STAFF REPORT: APPEAL DE NOVO COASTAL PERMIT

Appeal Number A-3-SLO-05-017, Pine Knolls Water Tanks

Applicant Cambria Community Services District

Project description Removal of two existing 103,000 gallon water tanks; construction of two new 550,000 gallon water tanks; relocation of electrical control panel and overhead electric service; replacement of 200 linear feet of waterline and valves.

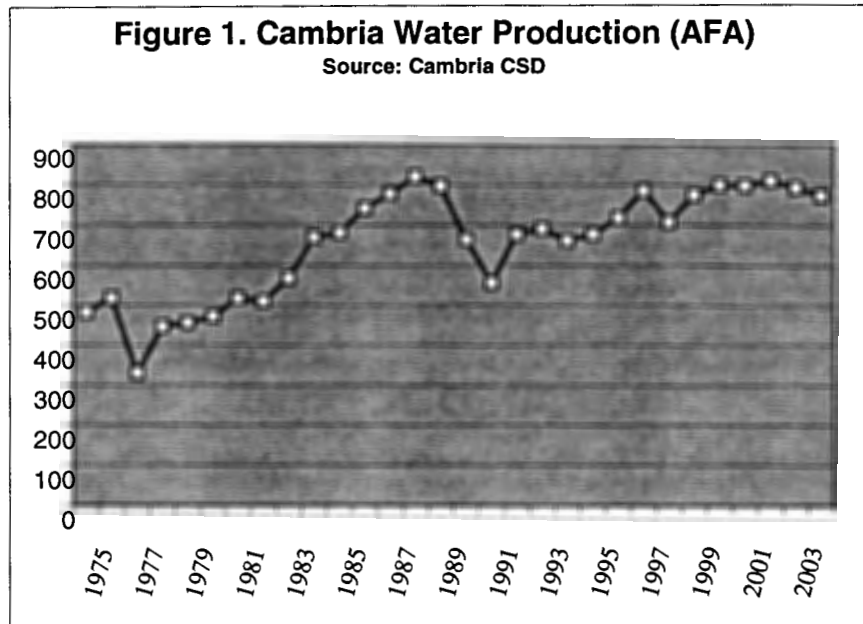
As mentioned, Cambria pumps its water from Santa Rosa and San Simeon Creeks. As shown in Figure 1, Cambria water production has increased over time as the population and the total number of connections has increased. In recent years, water production has leveled off around 800 acre-feet per year and has decreased in the last two years (793 AF in 2003; 773 AF in 2004; see also Exhibit X).

FIGURE 1

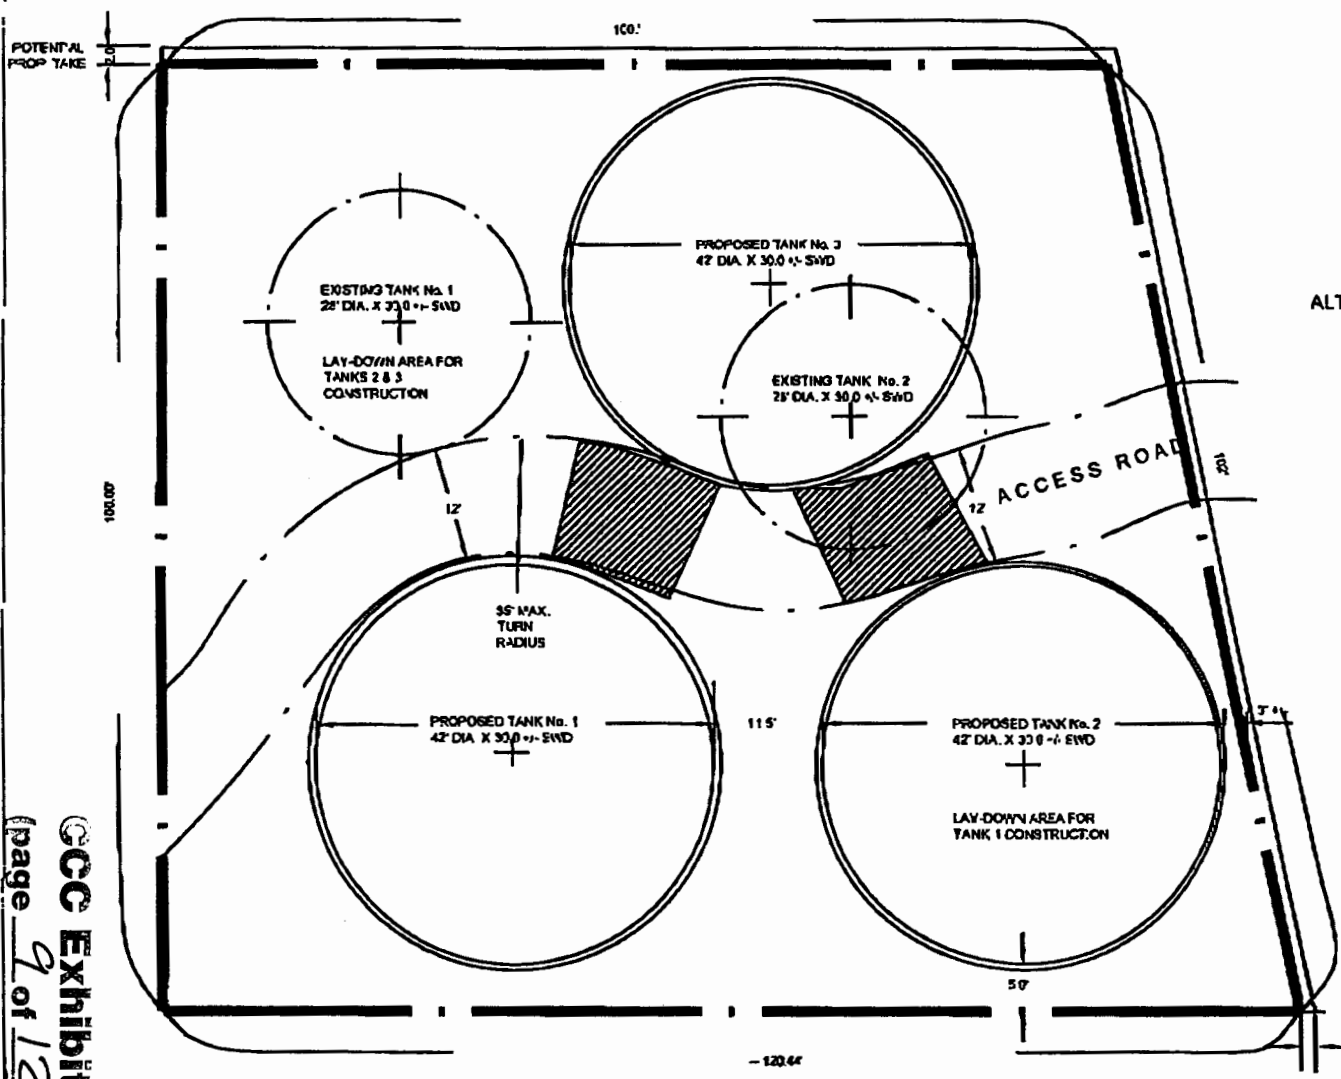
The two-tank alternative proposed by CCSD does not use the available area as efficiently as a three-tank arrangement. Figures 1 and 2 show possible three-tank combinations for meeting the current and future demands respectively at the existing Pine Knolls site. For the existing conditions, three tanks at 42' diameter would be required. For the 2011 conditions, 3 tanks at 44' diameter would be needed and some minimal encroachment would be required onto adjacent properties
